# Agenda Item # 5

## SUB-002566-2023

Lee’s Subdivision, Resubdivision of Lot 1

- Subdivision approval to create two (2) legal lots of record from one (1) existing legal lot of record.

# DETAIL SITE PLAN

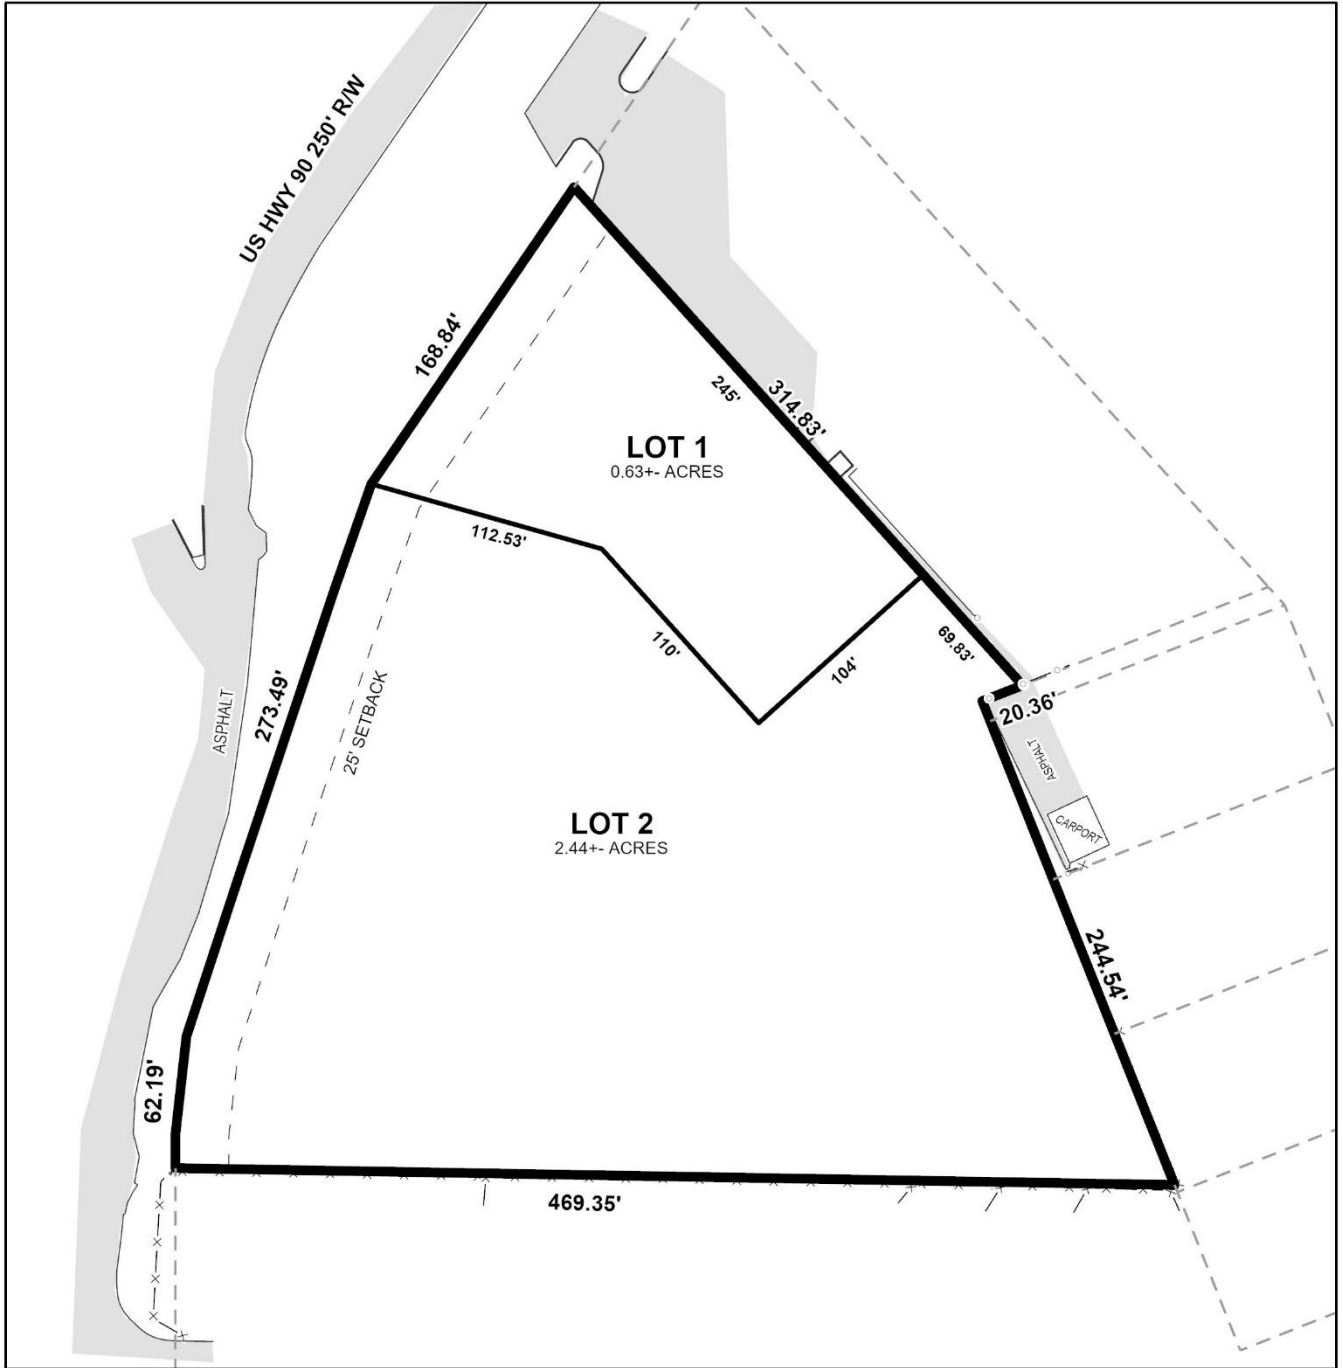
The proposed lots have frontages on Demetropolis Road, a Major Collector street without curb and gutter, requiring an 80-foot right-of-way, and US Highway 90 West (Government Boulevard), an ALDOT-maintained Principal Arterial street requiring a 250-foot right-of-way. The preliminary plat illustrates compliant rights-of-way for Demetropolis Road and US Highway 90 West (Government Boulevard); therefore, additional dedication should not be required.

Lot 1, as proposed, has frontage along an unimproved section of the Government Boulevard Service Road. Section 6.C.4. requires lots to abut a dedicated and maintained public street. As such, if approved, the Final Plat should illustrate access to Lot 1 via an improved public right-of-way or a shared access easement.

The preliminary plat submitted illustrates a 25-foot building setback line along all street frontages, which meets the minimum setback requirements of Section 64-2-14.E. of the Unified Development Code for lots in a B-3 Suburban District. This should be retained on the Final Plat, if approved.

The lots exceed the minimum size requirements of the Subdivision Regulations for lots served by public water and sanitary sewer services and are labeled with their sizes in square feet and acres. If approved, this information should be retained on the Final Plat.

1. Retention of all right-of-way widths as depicted on the preliminary plat;

2. Retention of the lot sizes in both square feet and acres, or the furnishing of a table on the Final Plat providing the same information;
3. Revision of the plat to illustrate access to Lot 1 via an improved public right-of-way or shared access easement;
4. Retention of setbacks as illustrated on the preliminary plat;
5. Compliance with all Engineering comments noted in this staff report;
6. Placement of a note on the Final Plat stating all Traffic Engineering comments noted in this staff report;
7. Compliance with all Urban Forestry comments noted in this staff report; and,
8. Compliance with all Fire Department comments noted in this staff report.
